**Proposal Concerning the Mandatory Installation of
Middle-Side Direction Indicator Lamps on Large Vehicles**

Submitted by the Experts from Japan

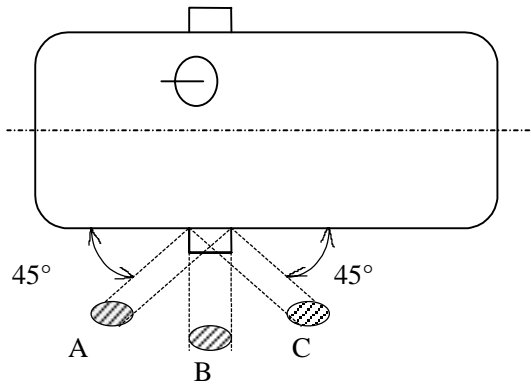
Amend to read: **5° outwards to 60° outwards to the rear as shown in Figure 2- 1.**

Figure 2-2

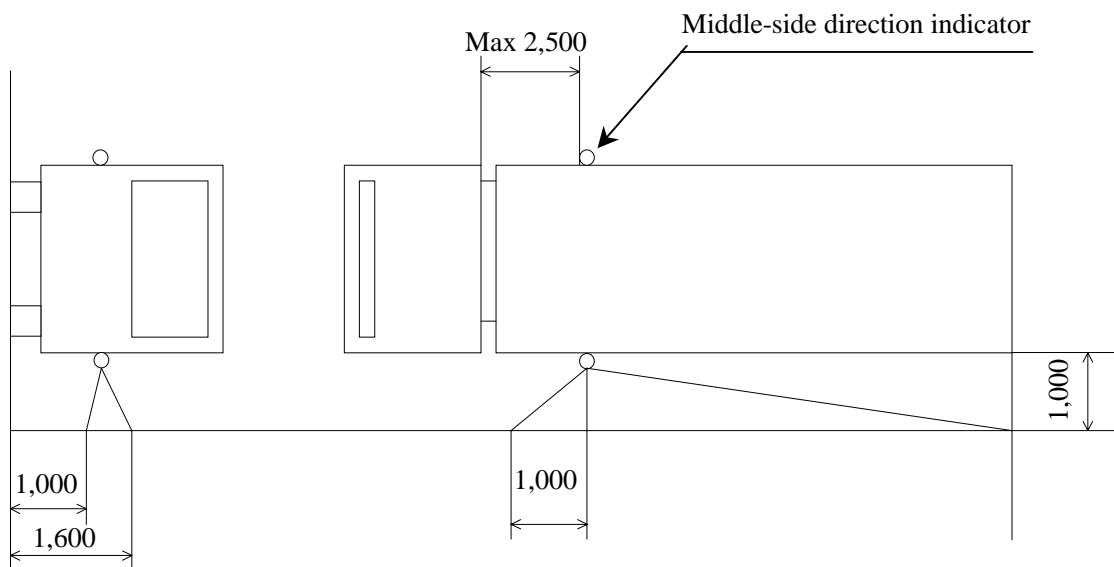
The middle-side direction indicator shall be visible from any point on the vertical plane 1,000 mm outwards of the vehicle's outermost point and parallel to the median longitudinal plane of the vehicle, and between a height of 1,000 mm and 1,600 mm from the ground and between the vertical line 1,000 mm forward to the installation position of the middle-side direction indicator and the other vertical line equidistant with the vehicle's rear end from the installation position of the middle-side direction indicator (see Figure 2-2).”

1,600 mm from the ground and between the vertical line 1,000 mm forward to the installation position of the middle-side direction indicator and the other vertical line equidistant with the vehicle's rear end from the installation position of the middle-side direction indicator (see Figure 2-2).”

“To ensure the visibility of the middle-side direction indicator from any point on the plane area shown in Figure 2-2, its minimum luminance shall be 3.0 cd or more at any point in the said plane area; or the projected area of the apparent surface of the middle-side direction indicator shall be at least 40 cm² as projected onto the vehicle's median longitudinal plane, onto the second plane intersecting with the median longitudinal plane at 45 degrees from forward, and onto the third plane intersecting with the median longitudinal plane at 45 degrees from rearward.”

Renumber Figure 2 to Figure 2-1, and add Figure 2-2.
